UNITED STATES PATENT AND TRADEMARK OFFICE

APPLICATION NO.	FILING DATE	FIRST NAMED INVENTOR	ATTORNEY DOCKET NO.	CONFIRMATION NO.
09/934,178	08/21/2001	Brian J. Brown	S63.2N-5605-US05	8077

Office Action Summary

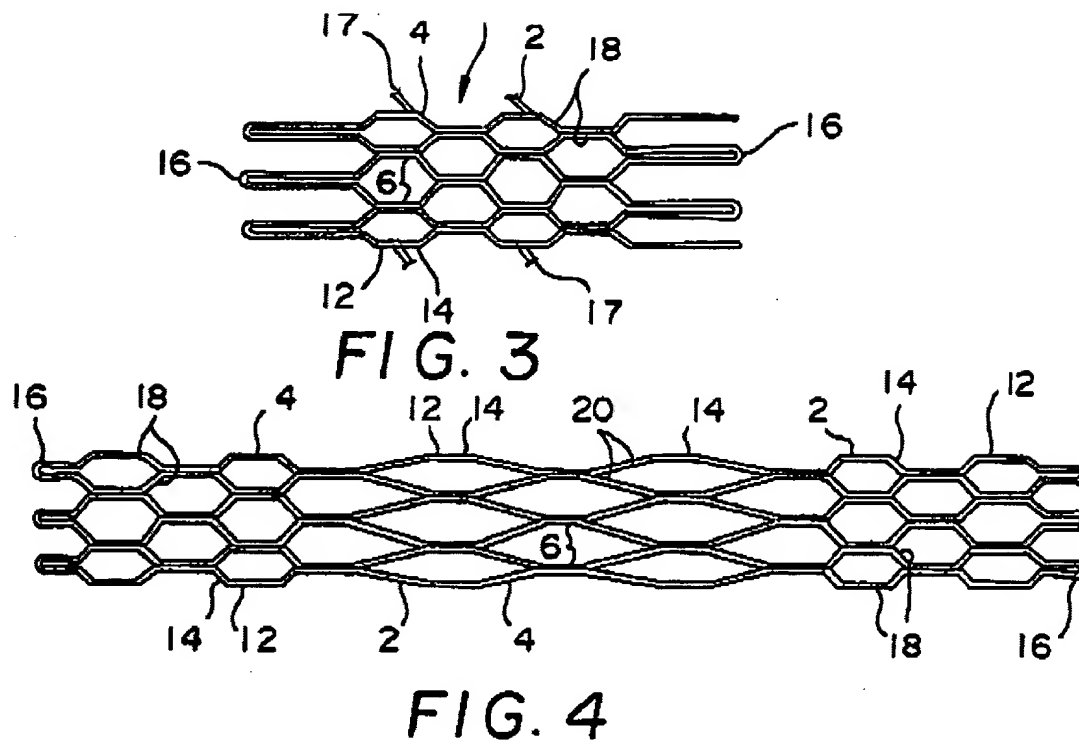
Claims 9-20 are rejected under 35 U.S.C. 102(e) as being anticipated by Kleshinski et al (US 5,902,317). Kleshinski anticipates the claim language where:

(1) the annular elements as claimed are the diagonal struts of wire (4) of Kleshinski;

(2) the struts of the ends are longer and inherently more flexible containing two strut straight struts such that the claim language is met requiring “a straight strut”;

(3) the straight struts of the non-end diagonal struts of Kleshinski are all the same length such that the language requiring “all the straight struts of an annular element are of the same length” is fully met; similarly, the peak portions and valley portions of the non-end annular elements are all of the same length as required;

(4) the “at least one connecting member” as claimed is at least one of the straight portions (6) of Kleshinski;

(5) the fingers of the end segments of Kleshinski provide greater flexibility; see column 4, lines 3-20, Figures 1 to 5 and column 3, line 45 to column 4, line 67;

(6) the “end offset in a circumferential direction for the [other] end” as claimed is met by Kleshinski because the circumferential direction can be along the cell circumference. **In other words, the circumferential direction can be any of at least six directions since the cells are hexagonal.**
